**Special Presentation for the
The Automatic Fire Alarm Association of New Jersey
September 20, 2012**

**Fire Alarm Permit Applications under the NJ Uniform
Construction Code.**

**John Drucker, CET
Fire Protection Subcode Official
Building, Fire, Electrical Inspector
Borough of Red Bank, NJ**

Re: Secure Lower Lobby Door Addition – Plan SK-1B

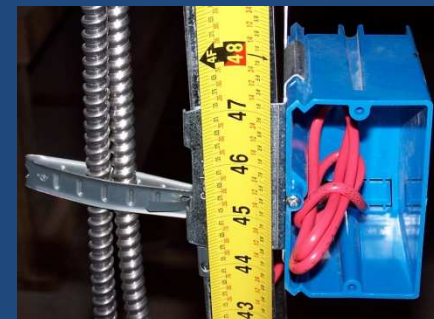
The application to secure lower lobby door addition cannot be approved for the following reasons;

1) The door is a component of the means of egress in both directions, a) as a second means of egress from the basement corridor and b) as a second means of egress from the basement lobby.

In this regard the exit door must be unsecured and readily accessible from both sides.

However the door to the "Bank File Space" may be electronically secured from the ingress side with the requisite fail safe provisions on the egress side, permits and inspection. Additionally electronic security measures such as alarms and or video monitoring are permissible.
